SUBJECT: Waterford 3 SES  
Docket No. 50-382  
Additional Information on Basemat Cracks

RESPONSE TO DR. J MA'S QUESTION  
OF 11/16/84

RESPONSE TO DR. J MA's QUESTION  
OF 11/16/84

## RESPONSE TO DR. J MA's QUESTION OF 11/26/84

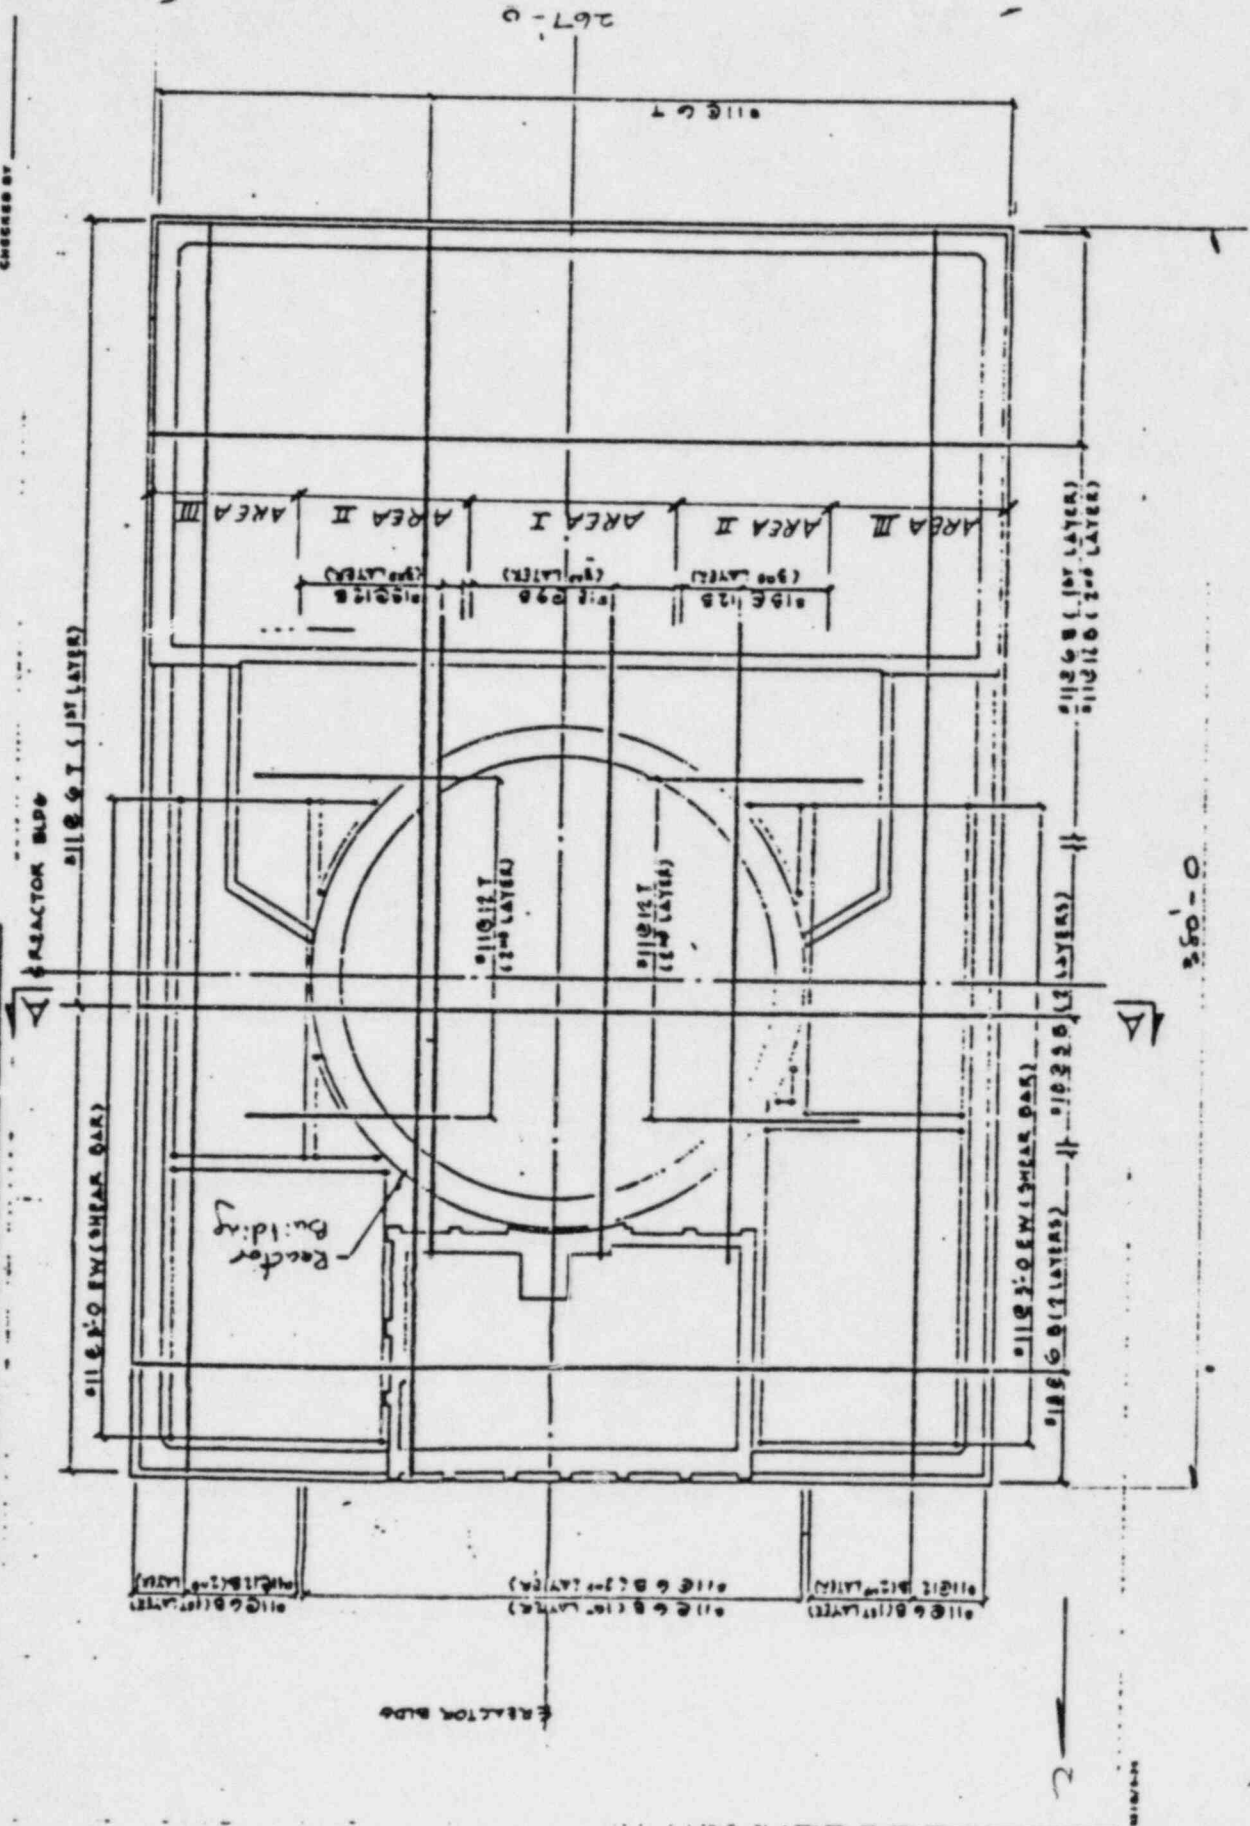
Q1. Provide locations of N-S top and bottom reinforcement of the basemat under and outside of the Reactor Building.

SH 2 Plan of the basemat - showing top and bottom reinforcement distribution, and areas of concern, Areas I, II and III along E-W centerline of the Reactor Building (Section A-A).

Ans. As-built N-S re-bar locations under and outside of the Reactor Building, along Section A-A, are shown in the attached sketches (SH 2/6 to 6/6)

SUBJECT COMMON PDN PLAN - REINA

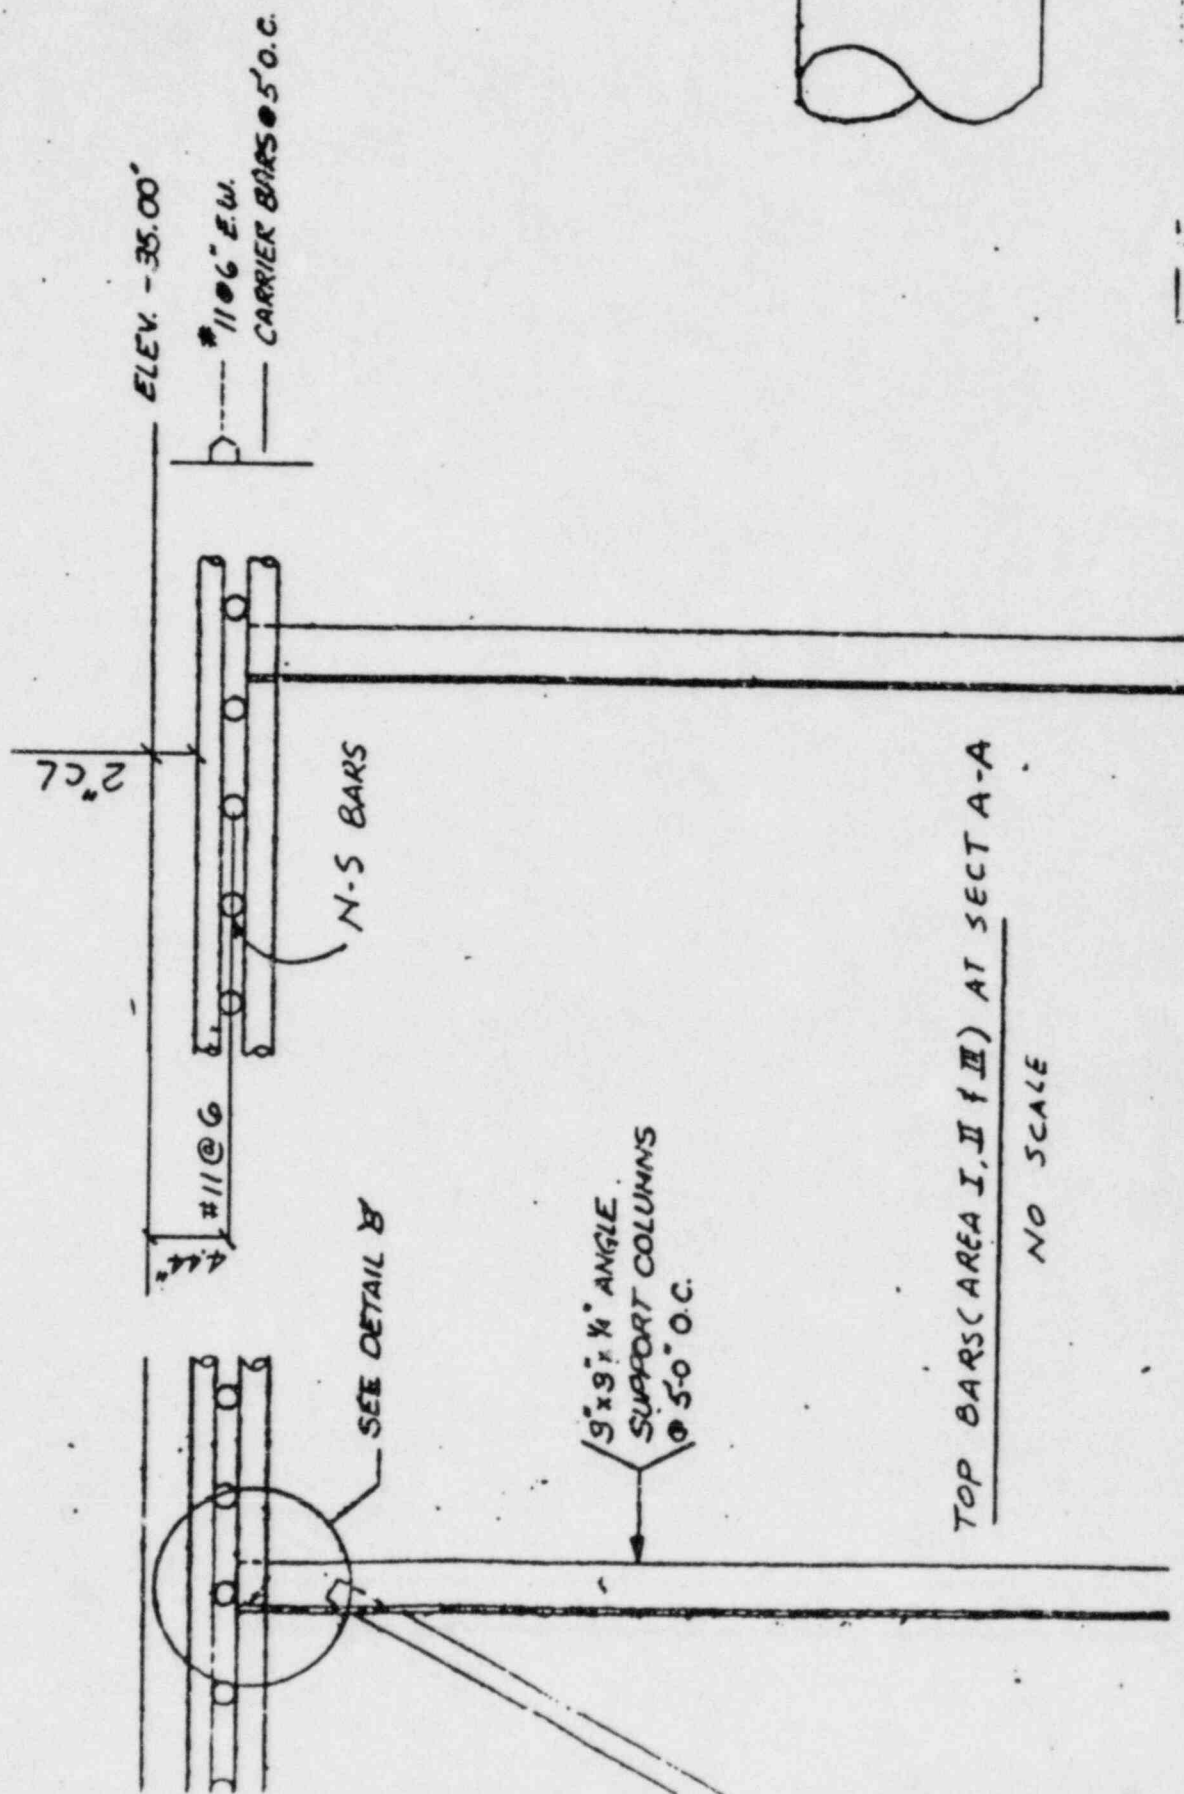
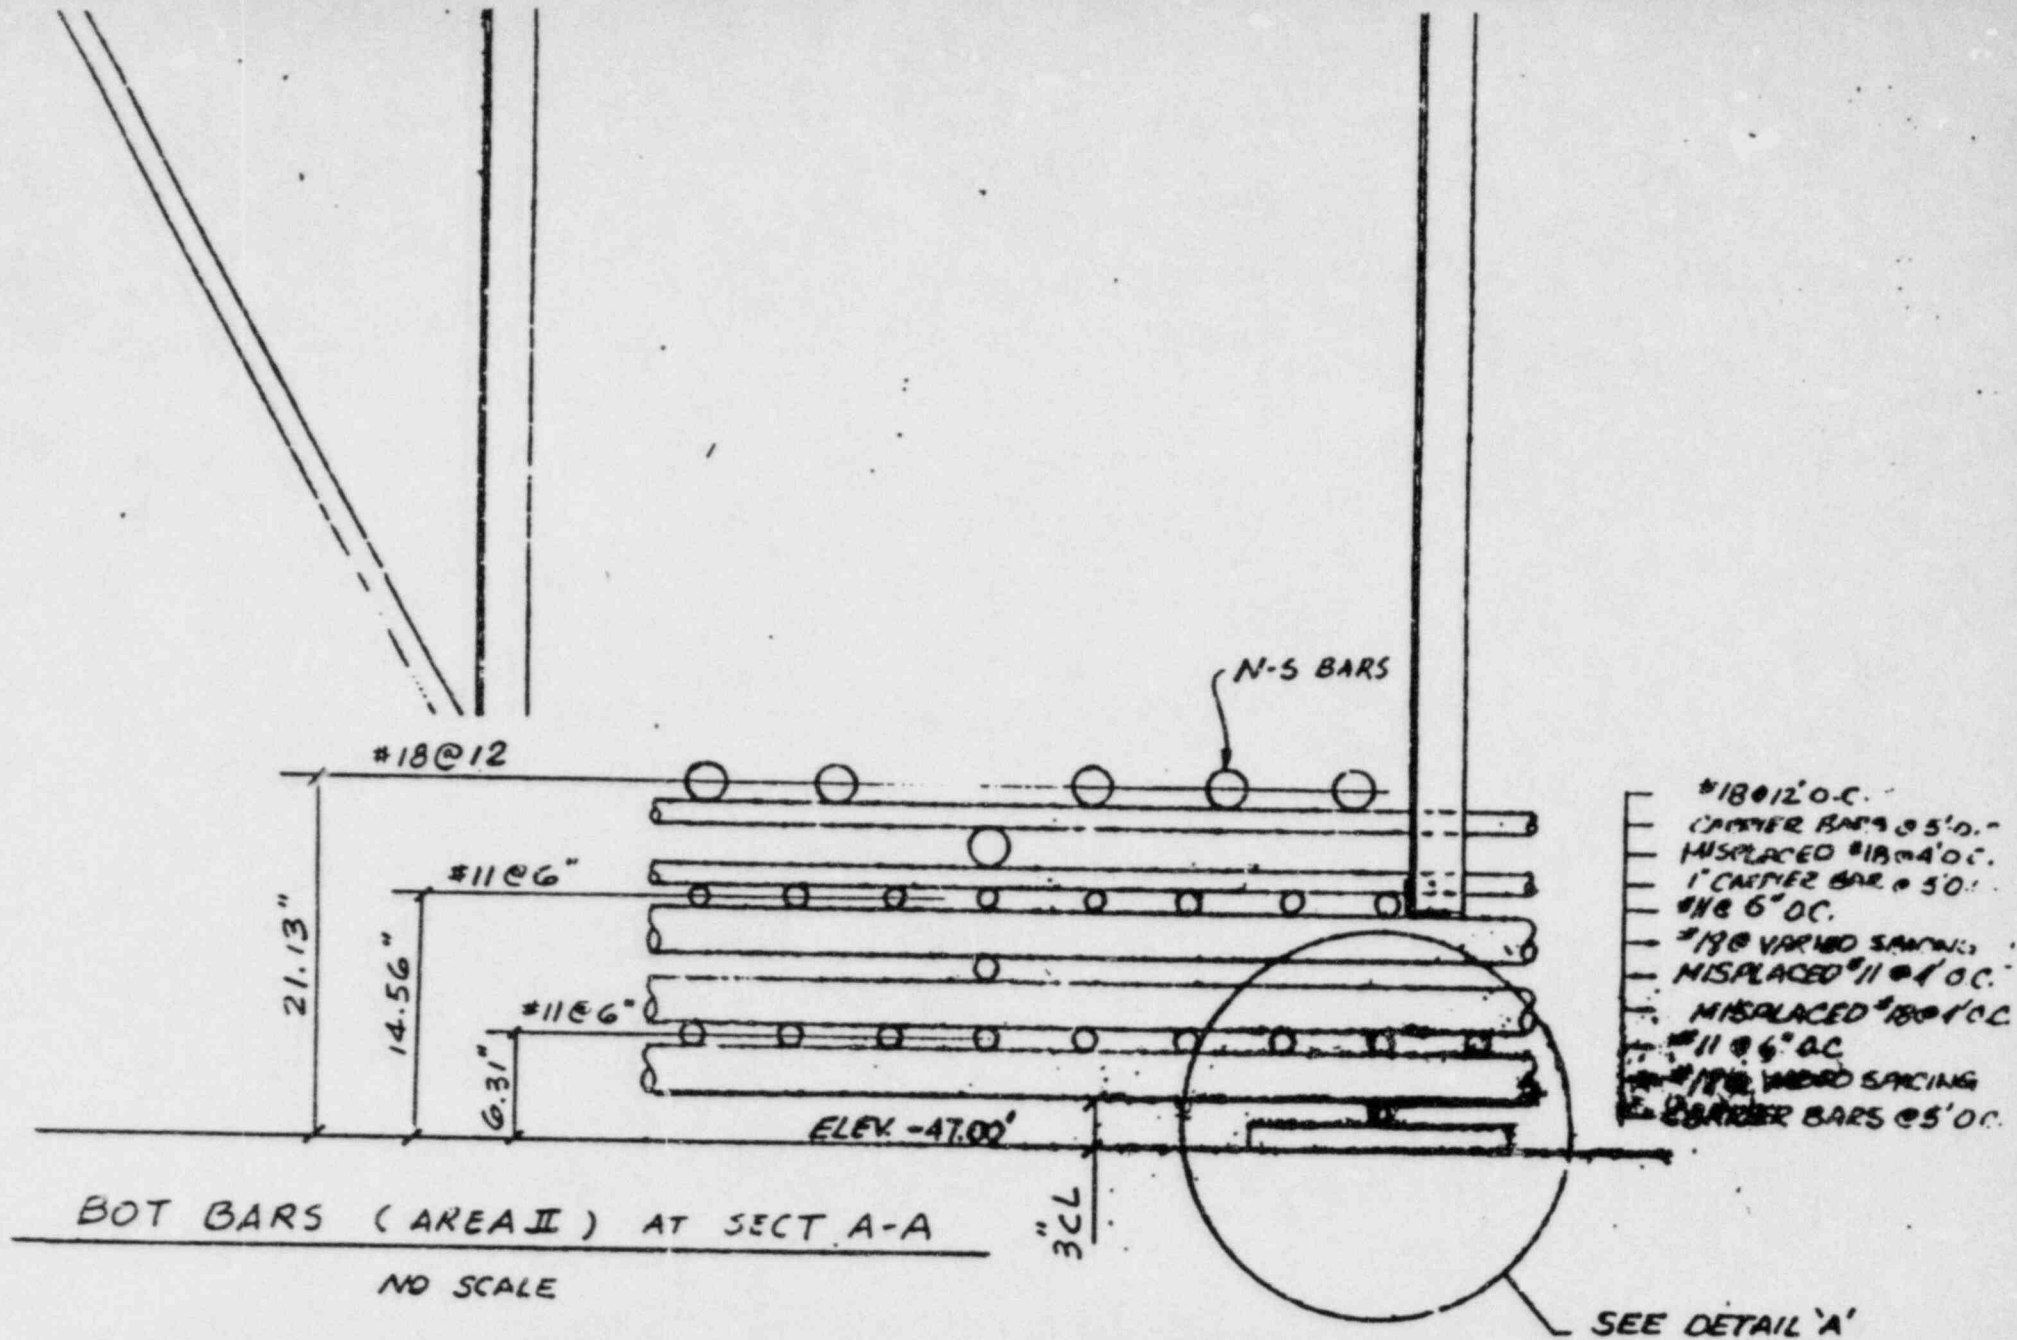
SH 3 N-S top re-bar locations for Areas I, II and III

SHEET 2 OF 7

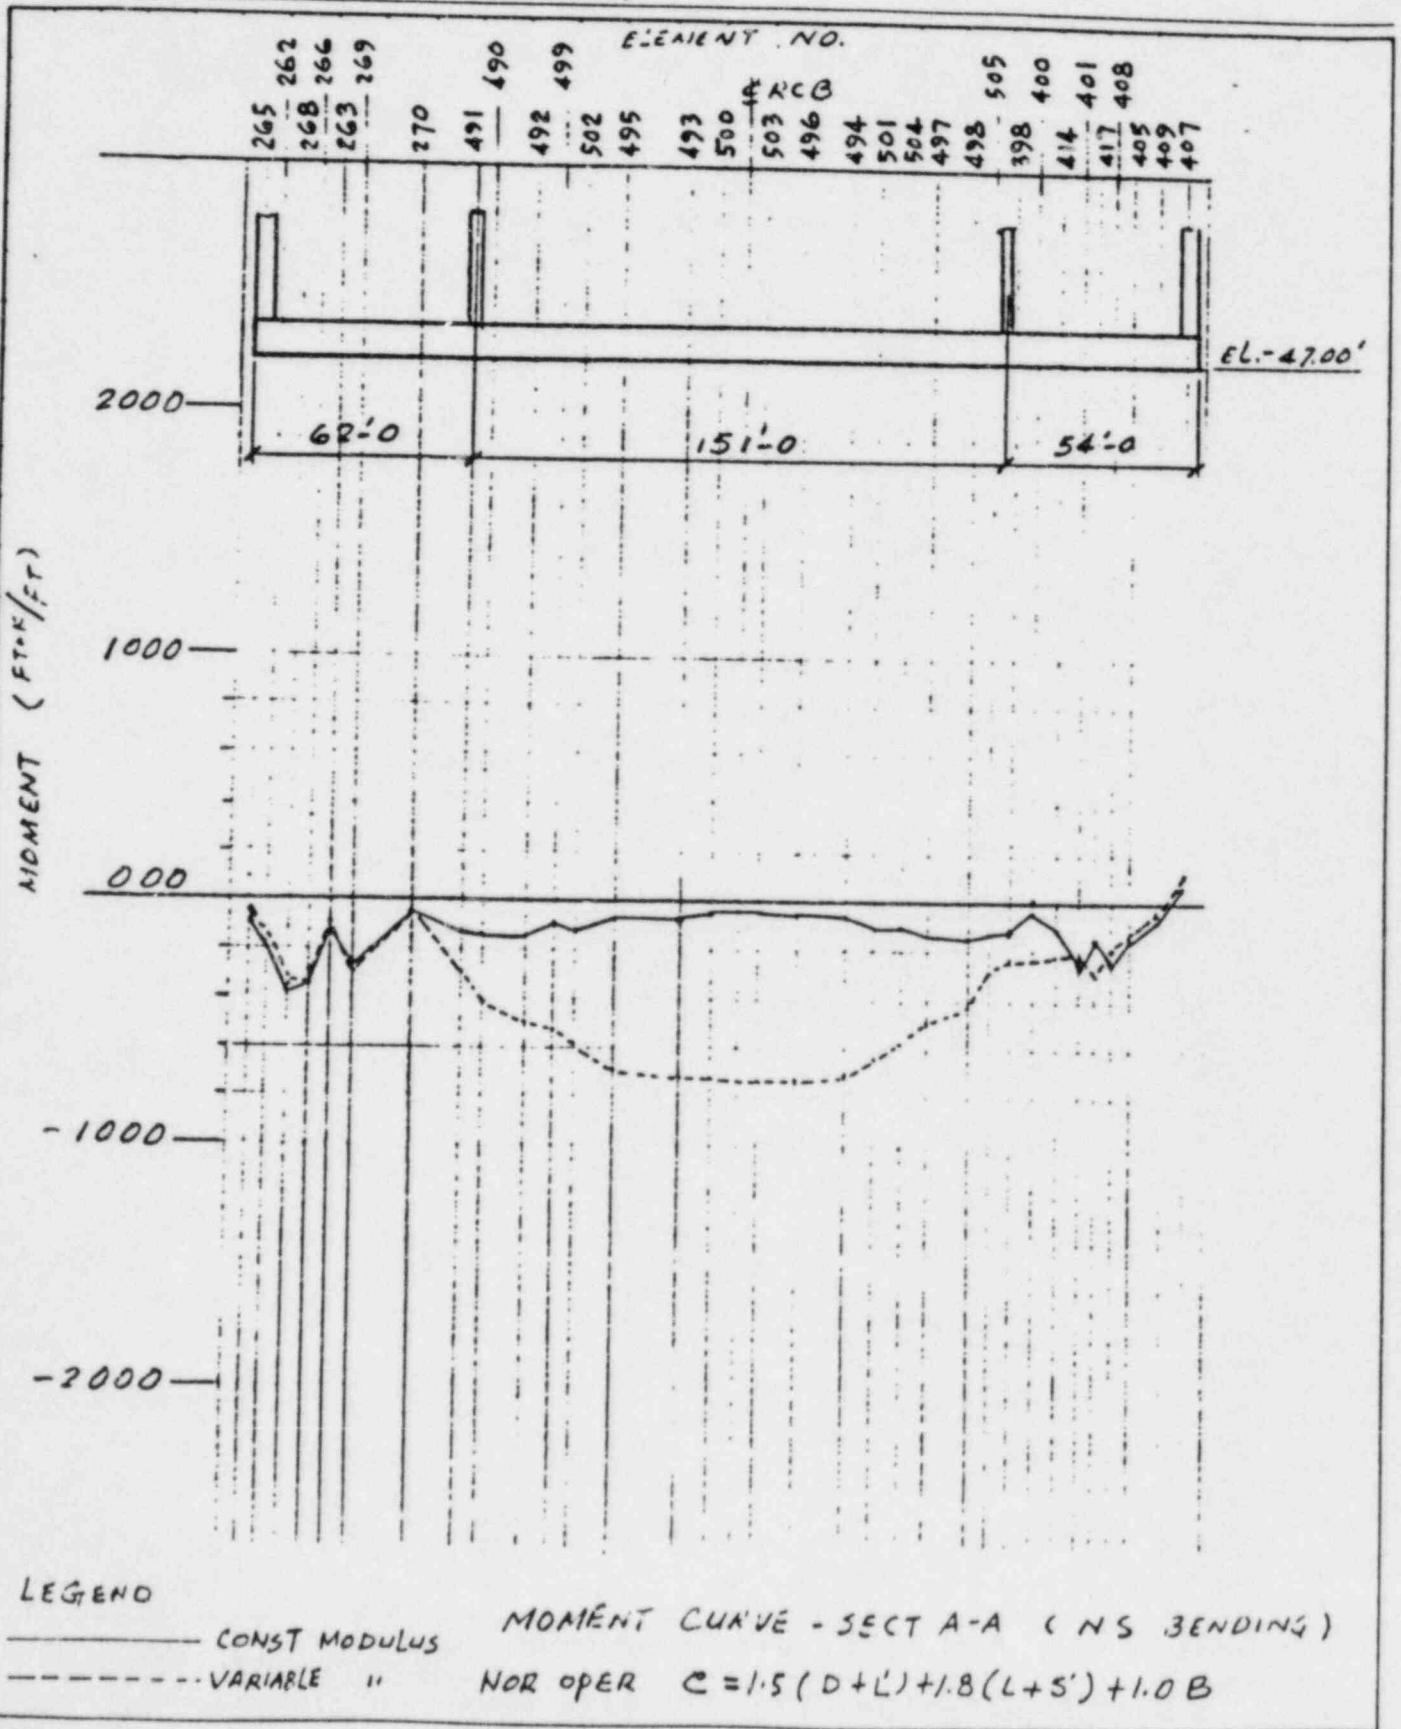
Q2. Provide N-S bending moment diagram along Section A-A of the basemat for the following load conditions:

- a. Constant soil springs with side soils
- b. Constant soil springs without side soils
- c. Variable soil springs with side soils
- d. Variable soil springs without side soils

Ans. a&c See Sh 2 of 7  
b&d See Sh 3 of 7
